Product Change Notification / RMES-05 VLTL542

CCB 4444 Final Notice: Qualification of G631HQ mold compound material for selected PIC32MZ1024ECx144, PIC32MZ2048ECx144, PIC32MZ0512EFx144, PIC32MZ1024EFx144, and PIC32MZ2048EFx144 device families available in 144L LQFP (20x20x1.4mm) package at ANAP assembly site.

**CCB 4444**  
**Pre and Post Change Summary**  
**PCN #: RMES-05VLT542**

**PCN#: RMES-05VLTL542**

## Pre Change

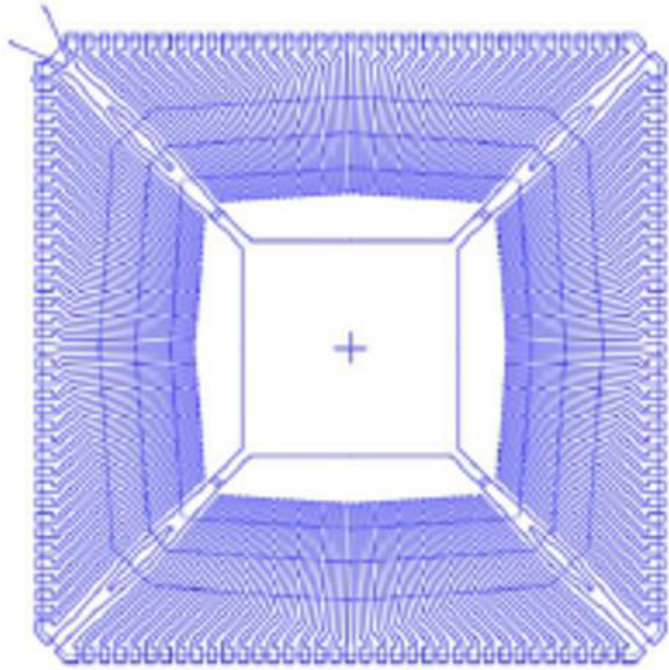
Strip Density	HDLF High Density Lead frame
DAP Surface Prep	Ring Ag
Backside Dimple	Yes

## Post Change

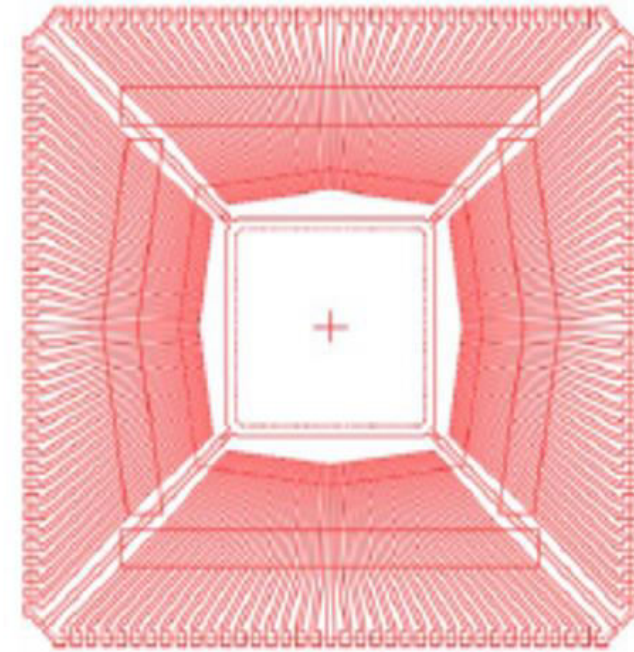
Strip Density	UDLF Ultra Density Lead frame
DAP Surface Prep	Double Ring Ag
Backside Dimple	No
